Consumers  
Power  
Company

September 30, 1983

MIDLAND ENERGY CENTER  
MIDLAND DOCKET NOS 50-329, 50-330  
EQUIPMENT QUALIFICATION AND THE SEISMIC MARGIN REVIEW  
FILE: B3.7.1/B3.10.4 SERIAL: 25647

FIGURE I-9-1: PROCESS TO SELECT COMPONENTS AND DISTRIBUTION SYSTEMS  
FOR SEISMIC SAFETY MARGIN EVALUATION AND DEVELOP MARGINS

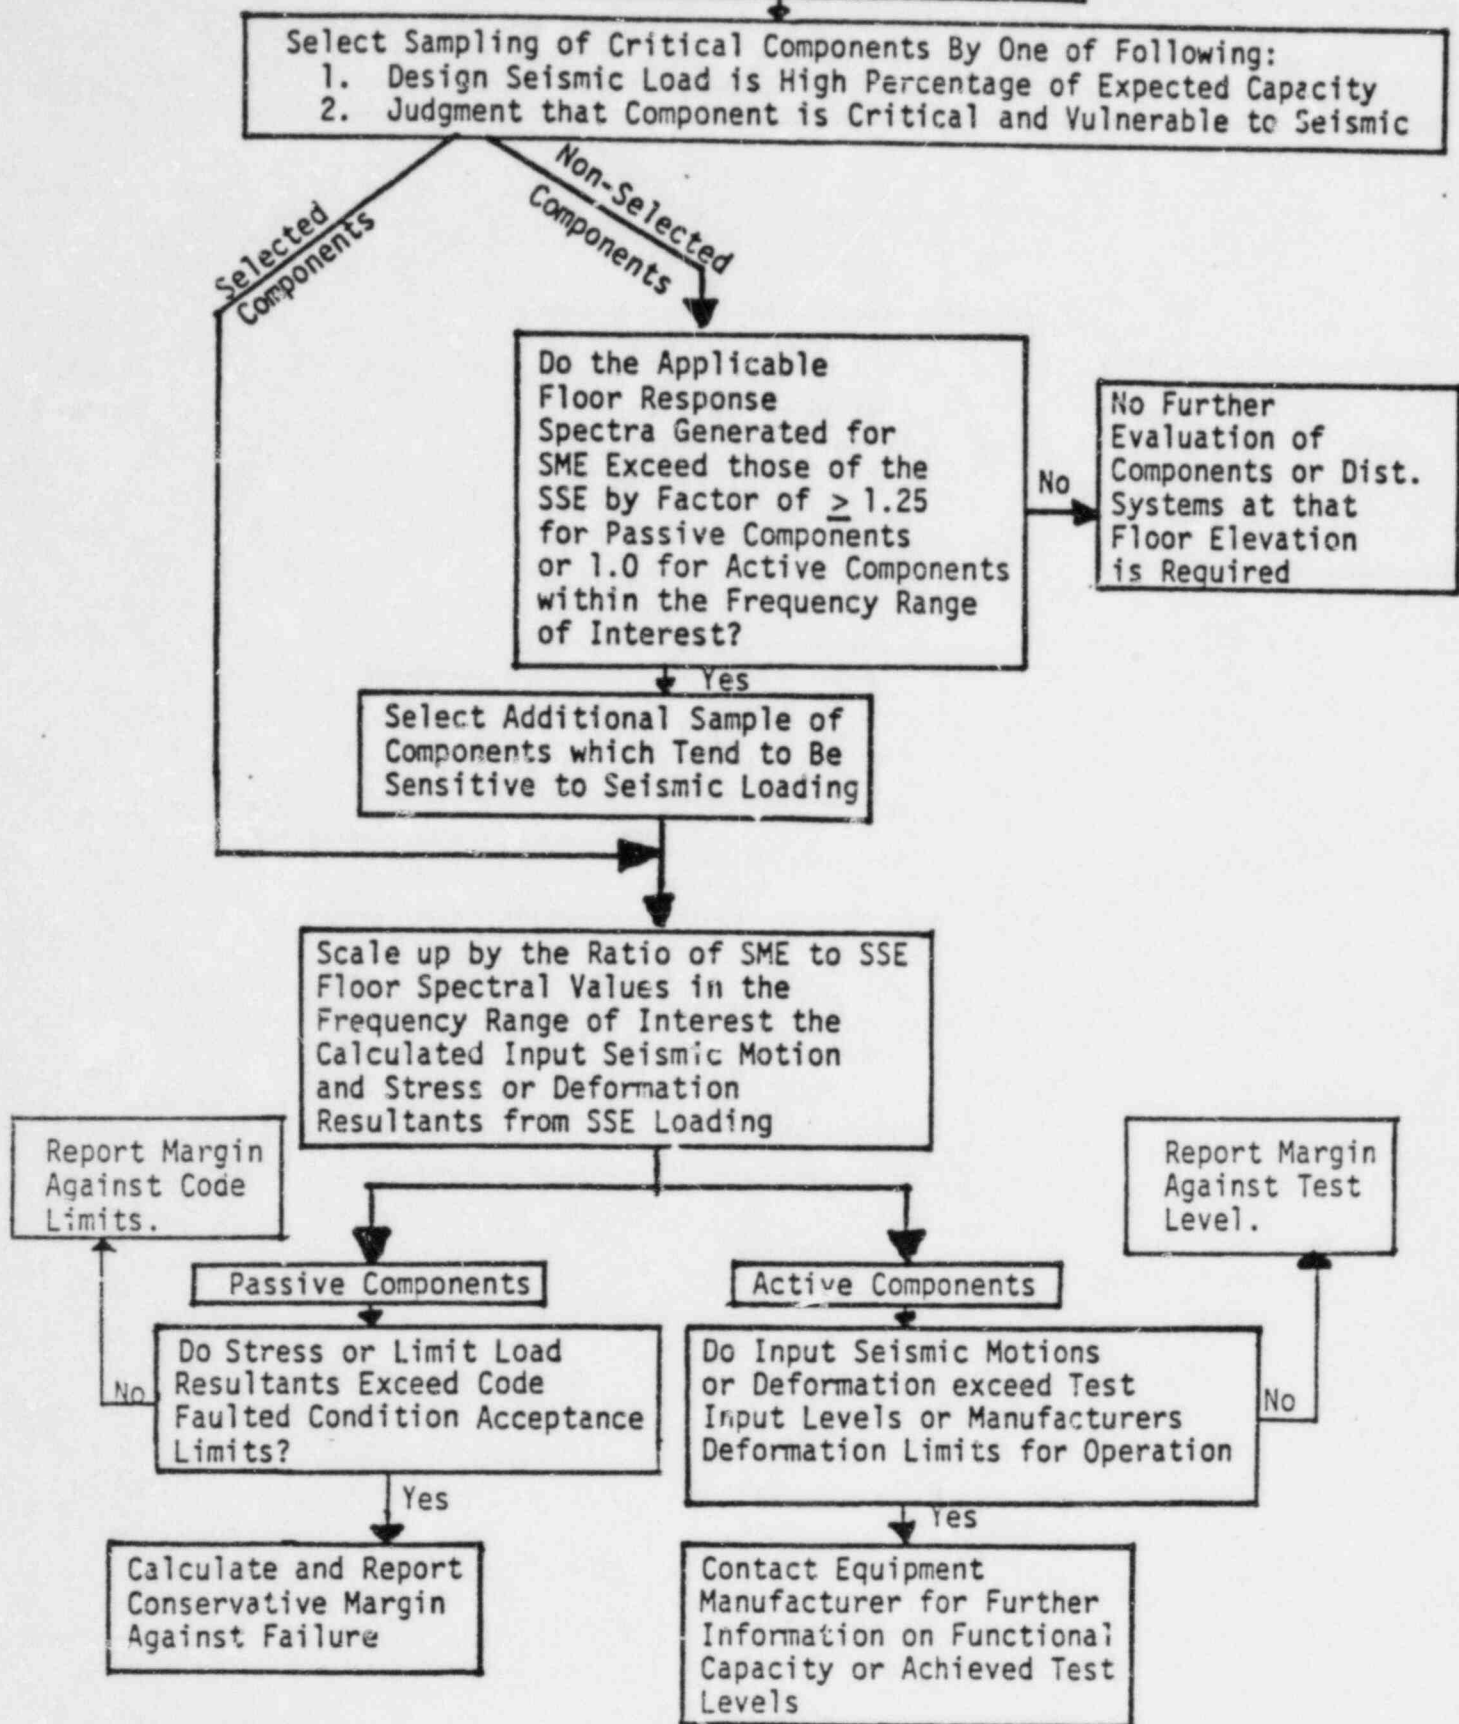
In the February 8, 1983 meeting with the NRC, CPCo discussed the methodology and criteria being used in the SMR Program for selection and evaluation of equipment. CPCo believes that a selected sample of equipment is adequate to demonstrate the ability to achieve and maintain safe shutdown of the reactors. Attachment A to this letter is a flowchart previously given to the Staff as a handout during the February 8, 1983 meeting. This attachment illustrates the process used to select equipment for evaluation. As can be seen in Attachment A, stresses, level of seismic response increases, functional importance and vulnerability are factored into the equipment selection process. The process of selecting equipment was originally presented to the Staff in a meeting in Bethesda on June 30, 1981 and subsequently modified in my telephone conversation with Mr J P Knight on July 17, 1981 to include a larger equipment selection. Based on the above discussions, it was our understanding that a systematic sampling plan would be appropriate for the SMR.

During the February 8, 1983 meeting, we presented the Staff with a listing of the equipment evaluated in the SMR. This listing also identified the respective margins of the equipment with the lowest margin conservatively estimated at 1.24. The equipment evaluated in the SMR included 100 percent of the 4160 Volt system including switchgear, 480 Volt motor control centers, station batteries, the diesel generator system, the major pumps, BOP logic cabinets, auxiliary shut down panel, the ESFAS cabinet, and the decay heat removal and component cooling water heat exchangers. The above equipment having been selected by the previously mentioned criteria.

As was stated in the February 8, 1983 meeting, approximately 35 percent of the essential equipment has been evaluated in the SMR. Based upon the methods used in the SMR for selecting the equipment for evaluation, we feel that what has been done is adequate to demonstrate functionality of the required equipment following an SSRS earthquake.
